CITY OF ALBUQUERQUE

Planning Department Transportation Development Services

**Re: SEC Cross Access Driveway, 1600 Gibson Blvd. SE
Traffic Circulation Layout
Engineer's Plan Stamp Dated 3-17-15 (M15-D012D)**

Project Number	2014055
Drawn By	JW
Checked	JW
Issue Date	March 17, 2015
Traffic Circulation Layout

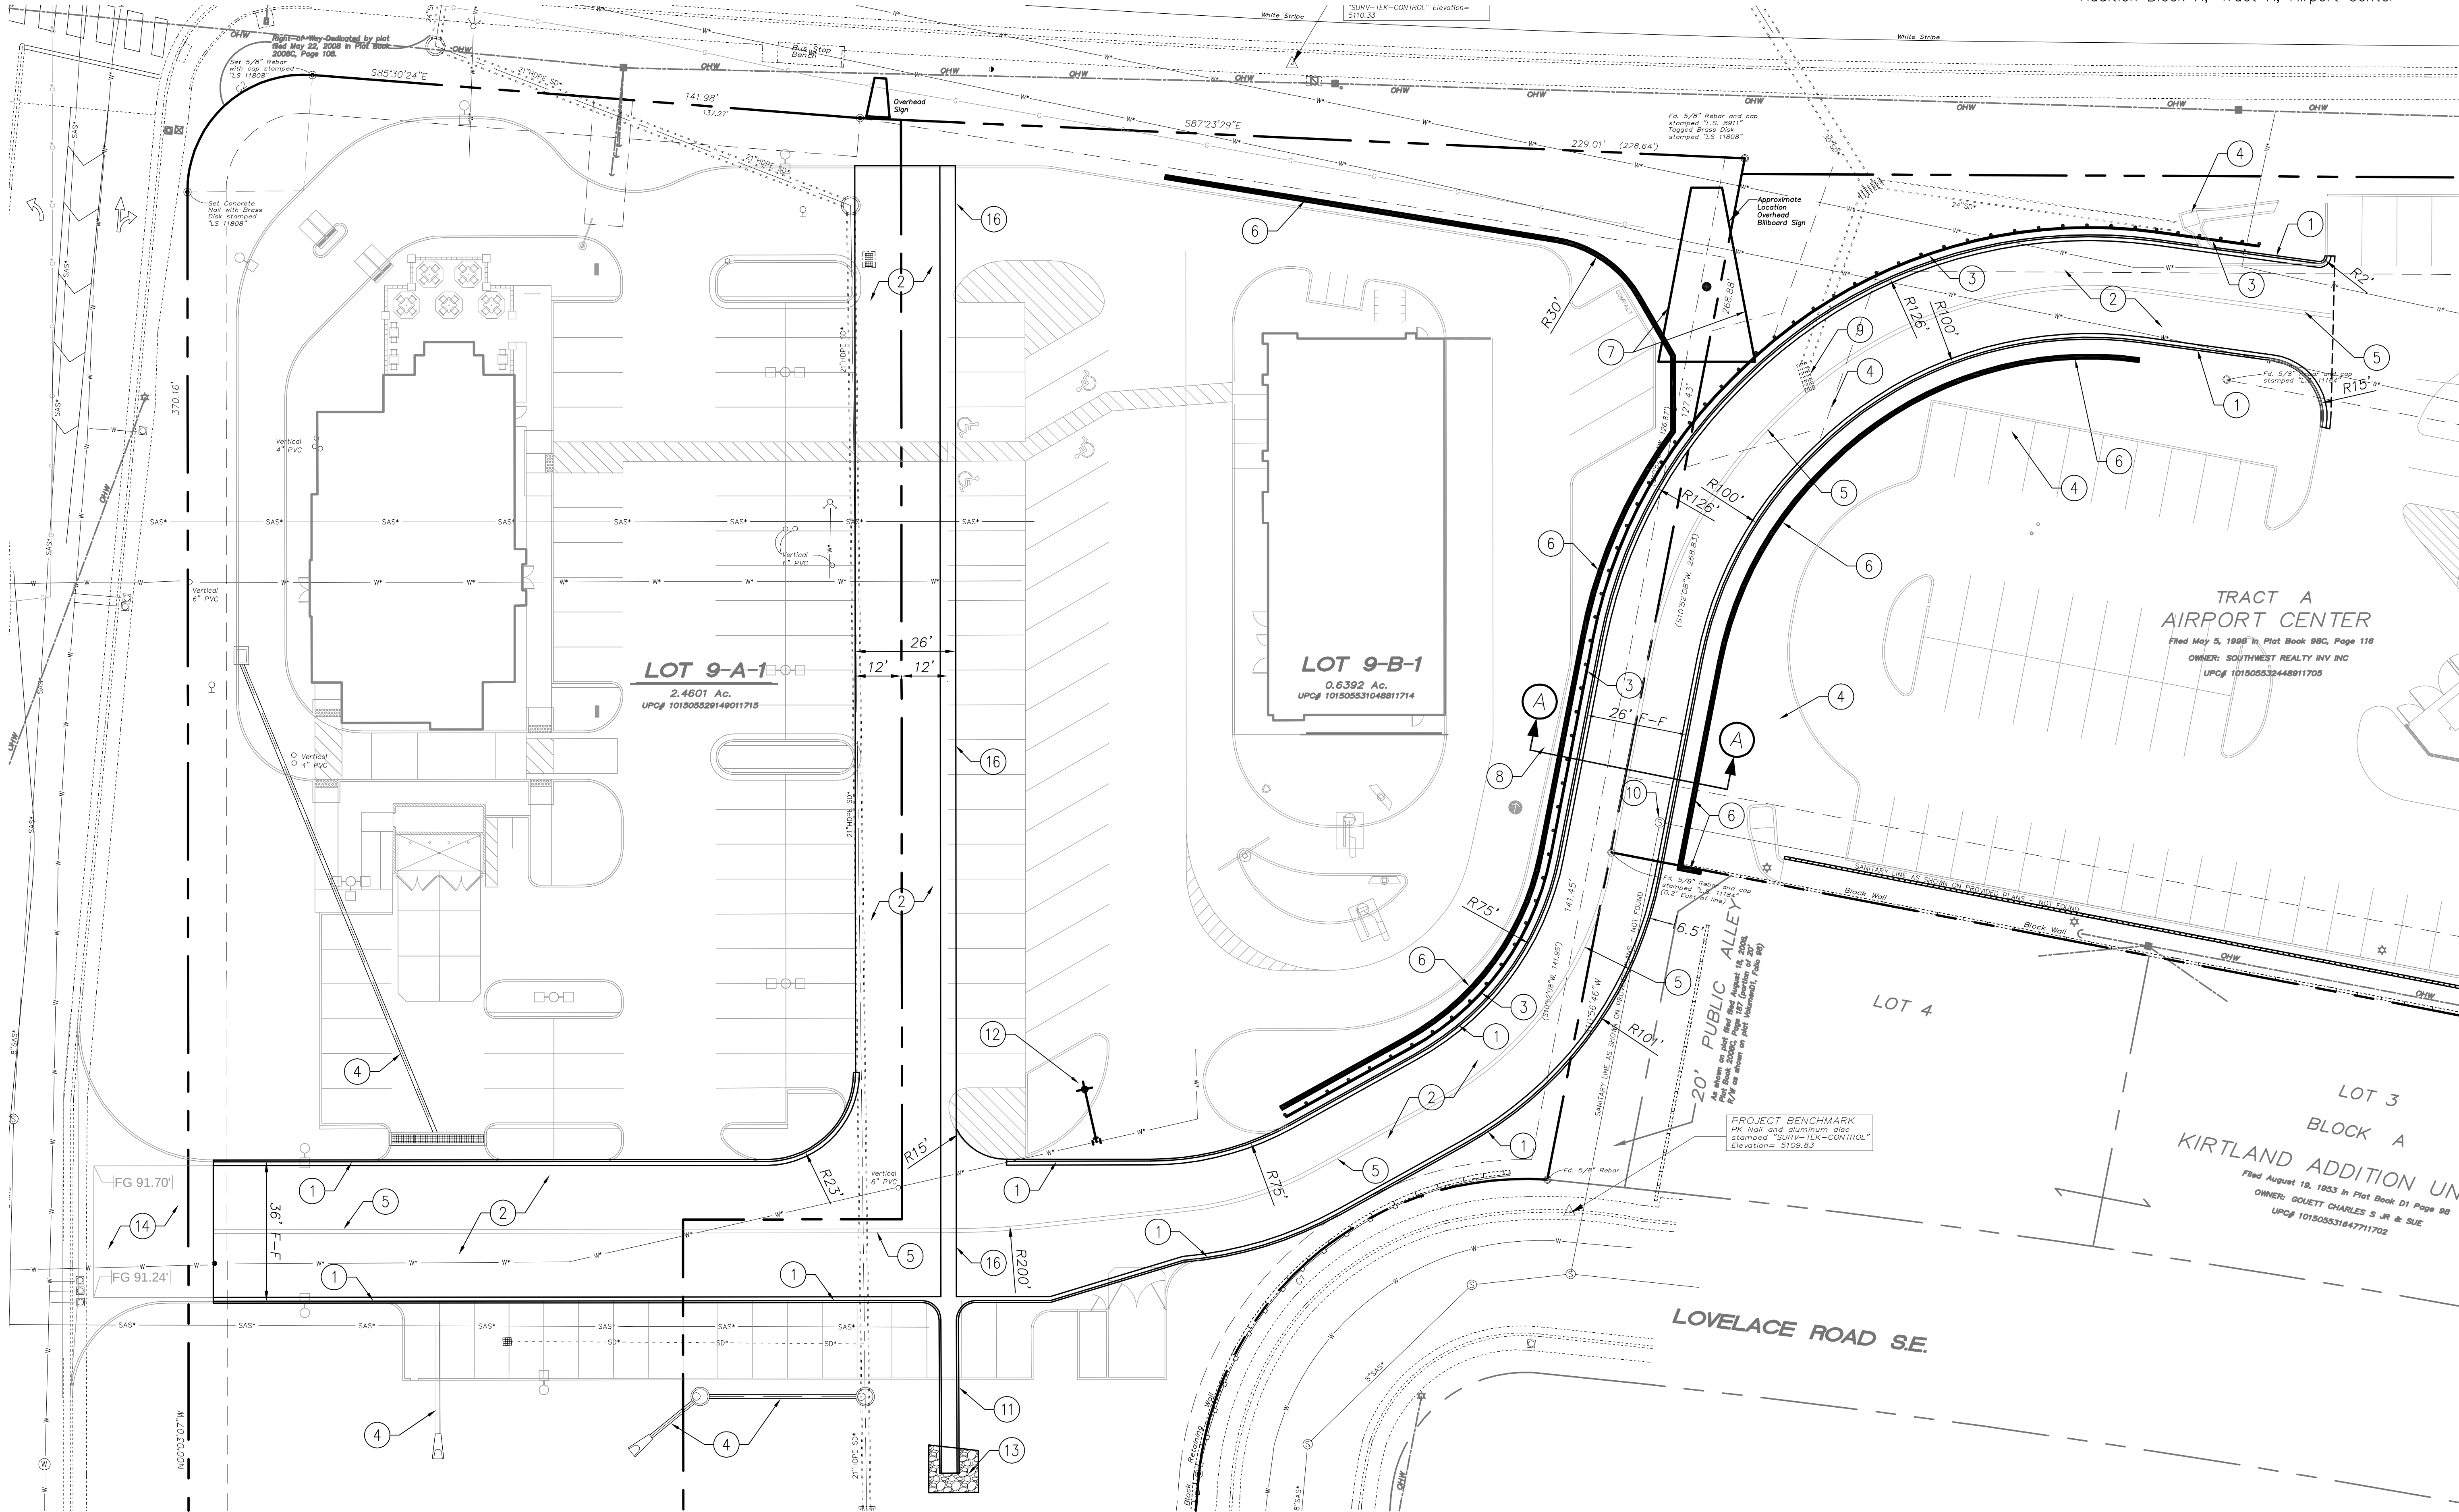
3. Clarify beginning and end of construction since this plan seems to conflict with Chick-Fil-A Construction. (For instance, a different paving section is being used for the accessway versus the Chick-Fil-A parking lot, and curb is shown along the north side of the accessway that conflicts with the parking lot access aisles into the Chick-Fil-A parking lot.)

5. East of the valley gutter where Keyed Note 16 is shown, provide a smoother curb transition by providing a radius where the accessway alignment changes.
